P21 93061

January 15, 1993
G-1151-JMK-93-023

Attachment(s): ANSYS Class3 Error Report 92-51, and QA Notice
QA92-14. Also 4.4 and 4.4A Class3 Error Summaries
by Report Number.

ANSYS® CLASS3 ERROR REPORT

NOTICE NO. QA92-14

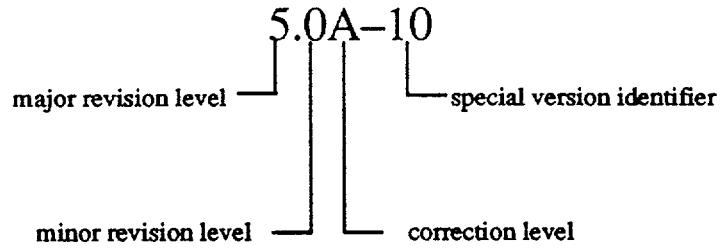
The behavior of solid model load deletion in the presence of other loads is not described adequately in the User's Manual. This notice clarifies a program behavior which may unintentionally delete loads.

Element edge pressures (or convections) that are applied directly (P, PSF, EP, CV, CVSF, EC, etc.), or transferred from LPSF (or LCVSF) load on a line, will be deleted in addition to the face load (from APSF or ACVSF) by SBCDEL,APSF (or SBCDEL,ACVSF) under the following conditions:

1. An area pressure or convection exists on an area which contains a non-shell area element,
- and 2. an area pressure (APSF) or area convection (ACVSF) is deleted from the area.

SBCDEL,APSF (or CVSFS) has been replaced at Rev. 5.0 with the SFADELE command, which does not exhibit this behavior.
